# Presentation of NM-26.0

## FB1170: FF-ICE/R1 services Correction & Tuning

v1.1

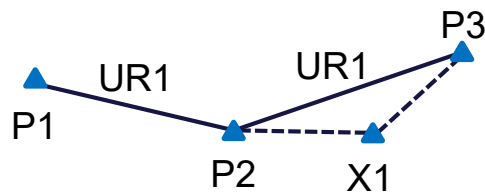
- NM-25.0 (current):

WARN313: TRAJECTORY INFO DISCARDED (NOT ON ROUTE : X1 PT)

NM-26.0: The route will be included:

WARN313: TRAJECTORY INFO DISCARDED (POINT X1 NOT ON SEGMENT P2 UR1 P3)
